# Design Principles and Standards

Proposed replacement photos

117 Campbell Lane

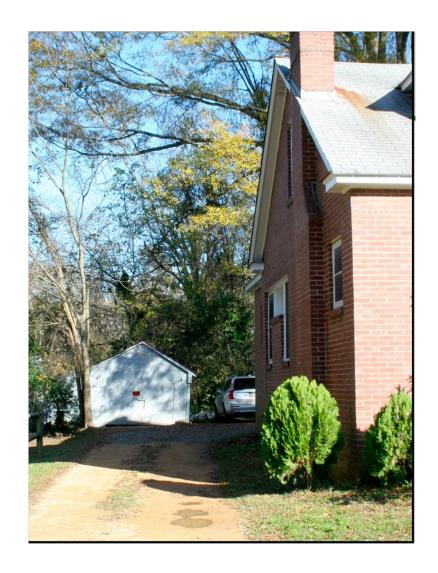
The design of 313 North Boundary Street is not a good example of the new standards, and in fact, it conflicts with the design standards: The orientation to the street, placement of the garage, and orientation of volumes are contradictory. There are no architectural features of the house that reference the historic character of the neighborhood or the district as a whole. The development of North Boundary Street extension in the late 1990s is as a whole an aberration and should not be included in the Franklin-Rosemary Historic District. The architectural styles of the extension are so varied that it is difficult to find an exemplary structure for a replacement. There is no need for a photograph to support the well-written text that explains the history of the extension.

This house and the following two alternatives are also located in the North Boundary extension but have designs more congruent with the historic structures in the Franklin-Rosemary district.

# Page 54 (bottom) Garages & Accessory Structures

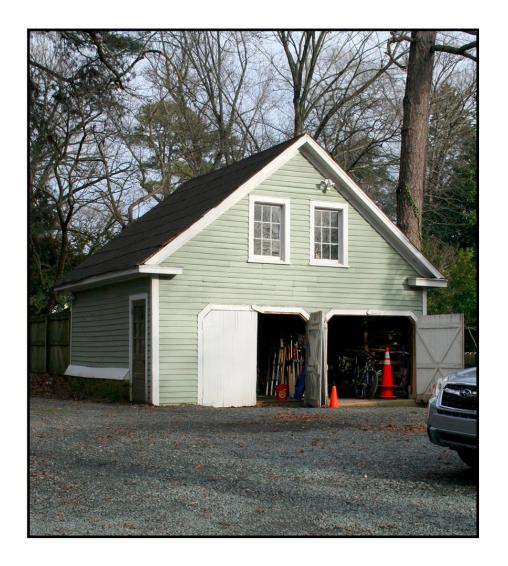
Caption inaccurately describes this as "one of a number of early-twentieth-century, one-and-a-half-story garages in Chapel Hill."
There were no one-and-a half-story garages in early-twentieth-century Chapel Hill.
(source: Sanborn maps) This garage is located at 405 Ransom Street where there was a one-story garage in this spot as of 1925.
[Source: Sanborn maps]

The photo, of 603 East Franklin Street, shows a 1925 one-story garage in context. The photo illustrates the height, scale, and placement of early-twentieth-century garages and accessory buildings.

## Page 72 Replacement

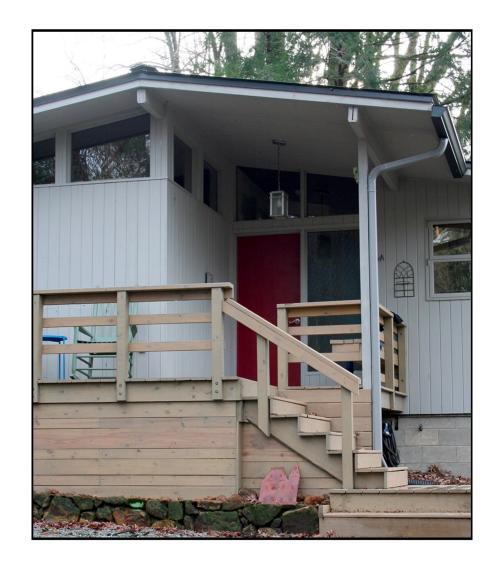
This roof replacement was an After-the-Fact COA that was denied by the HDC because the roofing materials were not an in-kind replacement as was explicitly stated in the former Guidelines p.37 #2 and #5. Similar wording is present in the newly adopted Design Standards under Roof, Gutters and Chimney Standards on pg.81 #3.1.4 & #3.1.5

Alternate metal roof photo. House located at N. Boundary and Rosemary.

## Page 85 Alternate Replacement

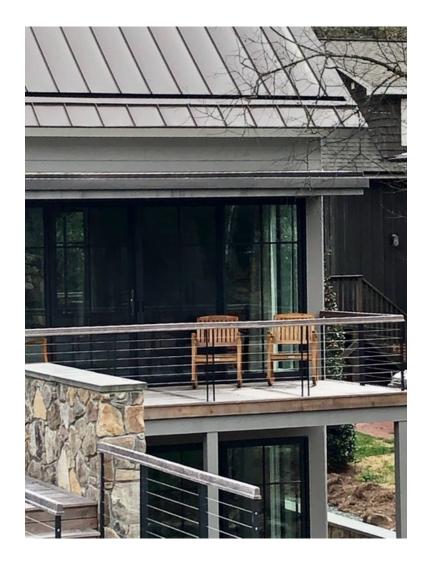
There are better, more interesting examples of modern architecture in our districts. In this photo, the railing looks unfinished.

This photo depicts some of the more modern features, such as clear flat surfaces, simple lines, larger windows, minimal ornamentation, unlike those found in the districts' older home styles.

### Page 132 Replacement

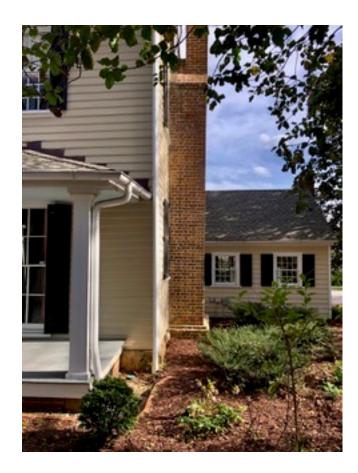
The photos on this page illustrate two additions: an addition to an addition that violates the principle illustrated by the drawing on the same page. The older addition is not differentiated from the original house.

The replacement photo is of a house (504 E. Franklin Street) built in 1814 with an addition on the west side of the house that was completed in 1966. The modern addition echoes a similar mid-nineteenth-century addition on the east side. This replacement photo illustrates the appropriate placement of an addition at the back of the house that is clearly differentiated from the original structure. It represents what the *Standards* describe as essential: an addition that does not overpower the original building, compromises neither its architectural integrity nor its history, and does not damage the setting. It is an example of how an historic property can remain in use for over two hundred years and of extending the useful life of a historic structure while providing modern comforts.

Alternate photo of addition to 504 E. Franklin St.

#### Cover photos

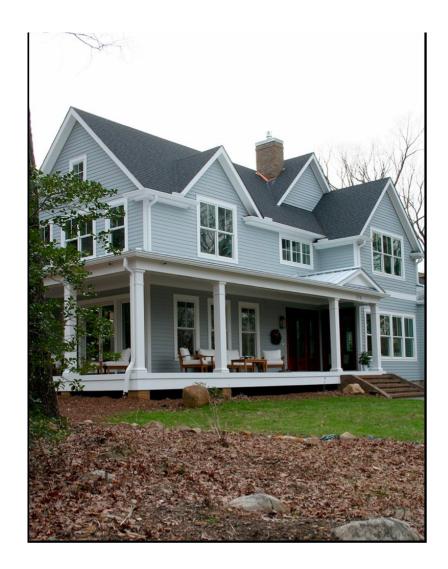
Bottom left: The existing photo depicts a very large new home in Gimghoul whose size is atypical in our districts. Above this photo is another large home and so it seems more important to show the diversity of properties that will be found inside the document.

Two possible photos of Bungalows might be used to replace the existing lower left photo. Either of these will illustrate more diversity in the architectural styles and sizes of homes found in all three districts. The front cover of the Design Standards is the place to represent this diversity as a means of introducing its contents. There are many Bungalow style homes in our historic districts so it seems important to take this opportunity to put one on the cover of the Standards document. The Old Tavern photo is included as a way to demonstrate history and perhaps could be used to replace the upper right photo. That design formatting can be worked out later.
